2 Type of change

New Configuration Code or change of Configuration Code

Product Change Notification					PCN for PG05 (Change Config.Code)		
owner	creation date	release date	released by	change order no	rev	page	D10-024-451
hollenpe	28.03.2018	05.07.2018	limachcl	2015365	A	1 of 2

1 Products affected

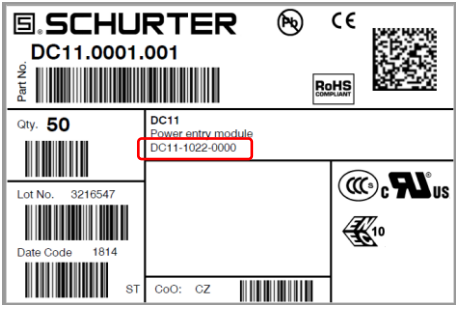
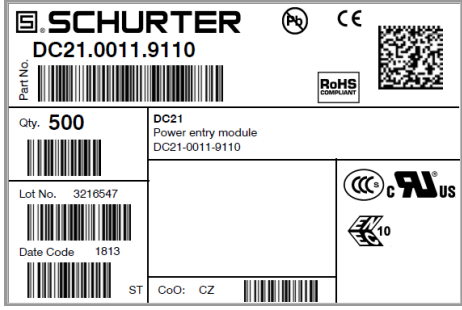
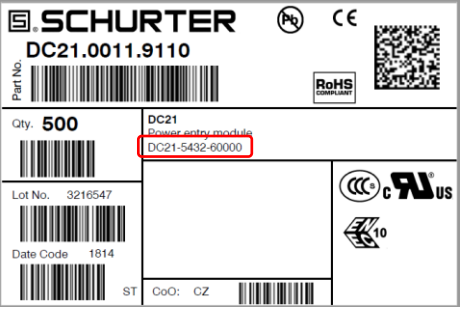
The configuration code has been modified. This change affects all the configuration codes depicted in documents by SCHURTER AG which refer to the affected products. This includes the packaging label and documents created in SAP(e.g. invoices, order papers, etc.). None of the part numbers will be altered and will remain the same as before. To secure a unique reference, SCHURTER asks the customer to refer to the part number for future correspondence. The configuration code can be used as a second reference to identify the technical properties of a product. Please check the list "Change of configuration code PG05_06_07" for a reference of the old and new configuration code with the according part number. You can find said list in the SCHURTER Partner Service on our website.

Old packaging label (without old CC)	New packaging label (with new CC)
 <p>Part No. DC11.0001.001 Qty. 50 Lot No. 3216547 Date Code 1813 DC11 Power entry module CoO: CZ</p>	 <p>Part No. DC11.0001.001 Qty. 50 Lot No. 3216547 Date Code 1814 DC11 Power entry module DC11-1022-0000 CoO: CZ</p>
Old packaging label (with old CC)	New packaging label (with new CC)
 <p>Part No. DC21.0011.9110 Qty. 500 Lot No. 3216547 Date Code 1813 DC21 Power entry module DC21-0011-9110 CoO: CZ</p>	 <p>Part No. DC21.0011.9110 Qty. 500 Lot No. 3216547 Date Code 1814 DC21 Power entry module DC21-5432-60000 CoO: CZ</p>
